ENGINEERING PRACTICE STUDY

PROJECT NUMBER: 5961-2008-045

TITLE: REVIEW OF REQUIREMENTS FOR MIL-STD-750 TEST METHOD 2071

FINAL REPORT

FIGURE 2071-7. Meniscus cracks.

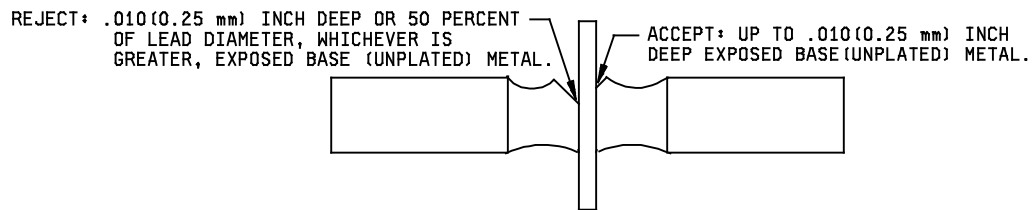
- a) The required inspection apparatus minimum magnification has been changed from 3X to 20X.
- b) Reject criteria has been updated to include any mechanical damage which exposes underplate or base metal.
- c) Reject criteria has been updated to include meniscus cracks.

- g. Glass meniscus cracks that are not located within one-half of the distance between the lead to the case (see figure 2071-7). The glass meniscus is defined as that area of glass that wicks up the lead or terminal.
